1 Products affected

2 Type of change

Product Change Notification					PCN KE			
owner	creation date	release date	released by	change order no	rev	page	D10-040-930	
huberth	08.11.2019	04.12.2019	limachcl	2018703	Α	1 of 1

3 Detailed description of change

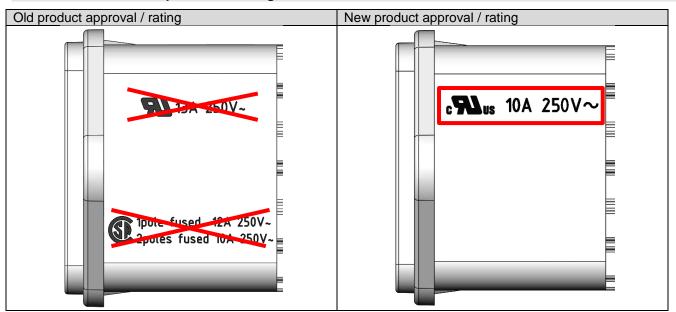
Change of approval markings from UR and CSA to the combined cURus on the part numbers with a socket for screw-on mounting.

Form Yes Socket new with cURus approval marking (@ 10A 250VAC)
